Appendix F – Critical Reservoir Elevation Compilation

Reservoir Intake Level (based on as-built pumping capacity) as of July 2025, updated June 2026

RAW WATER PUMPING STATION
PLANS & SECTIONS

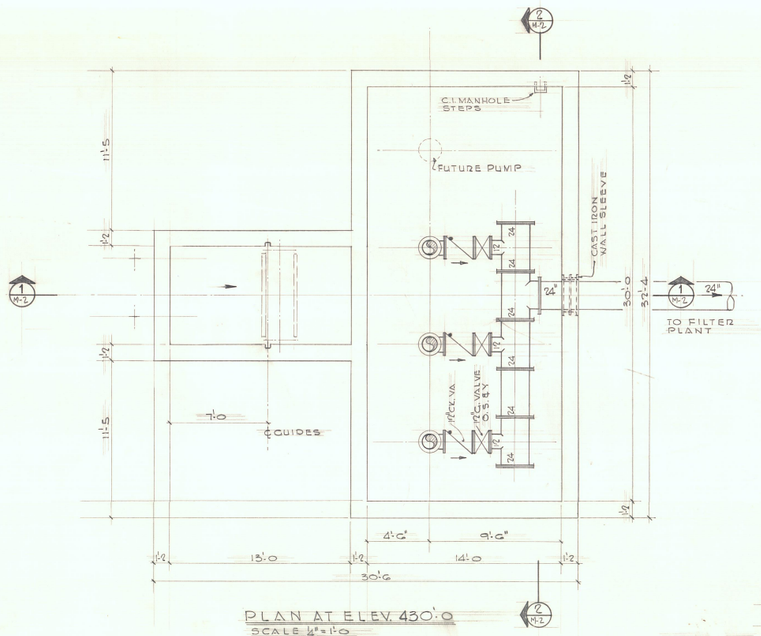
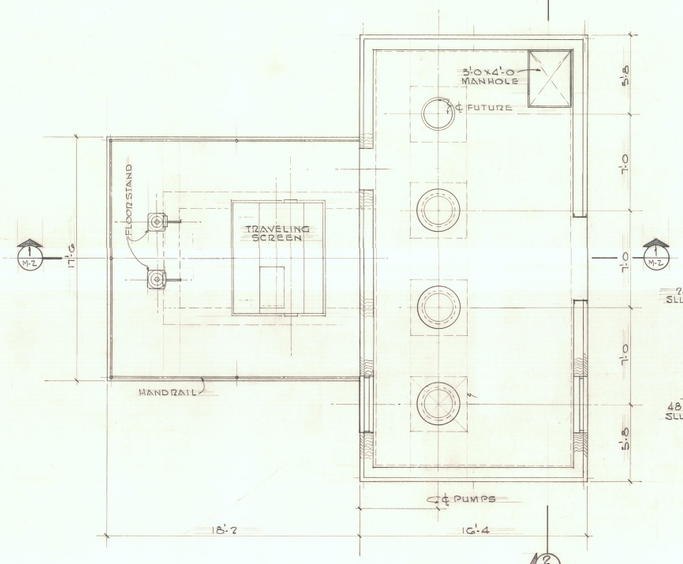
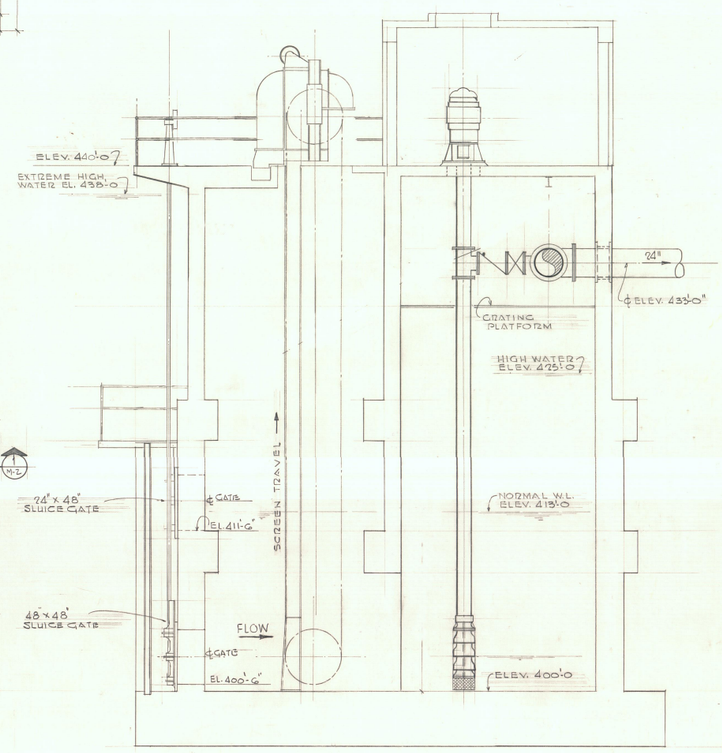
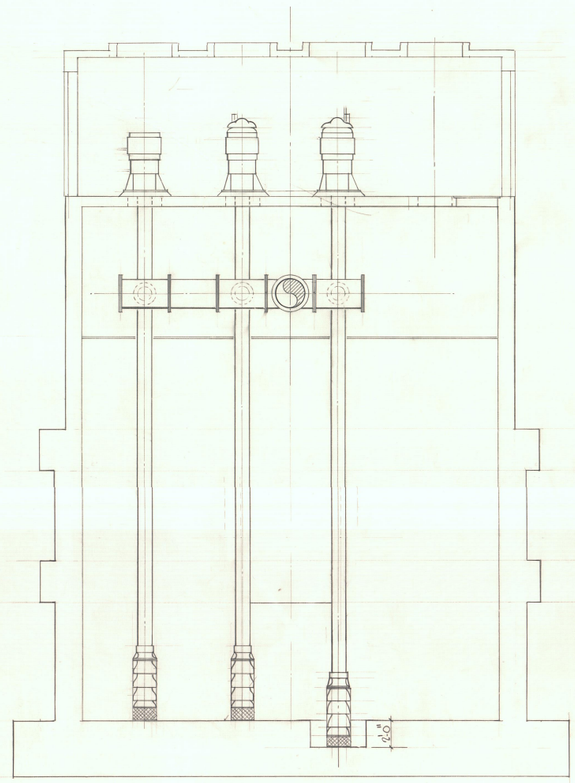
Based on the information on the attached plan sheet and the minimum submergence calculation (6'), the minimum elevation for operation of our intake is 407.00. Please let us know if you have any questions.

EXISTING INTAKE STRUCTURE MODIFICATIONS PLAN
@ EL 741.00
1/4" = 1'-0"

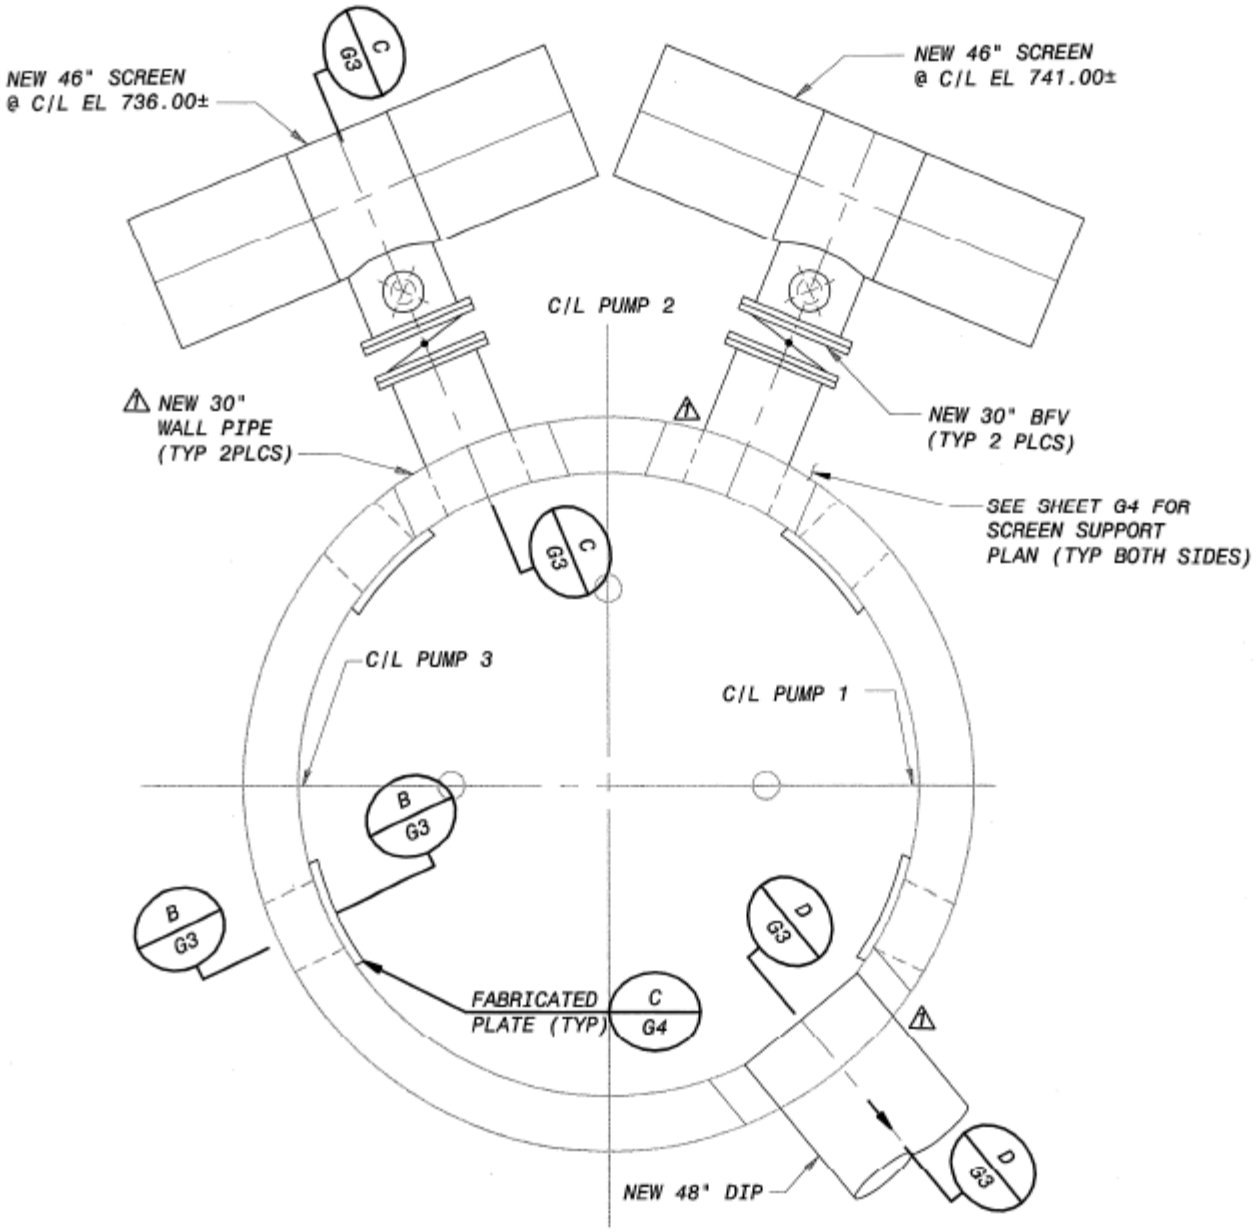
The highest of two screen on our intake structure has a centerline elevation of 741', and the lower is 736'. We've never done a hydraulic study (at least not to my knowledge) to verify capacity of just one screen at a future higher pumping rate to know if we could comfortably go without the top screen. But I'd be ok with using the top of the upper screen as the minimum level for the time being. I think it would be wise to find a place in the IWRP, maybe an appendix, to include these types of qualifiers.
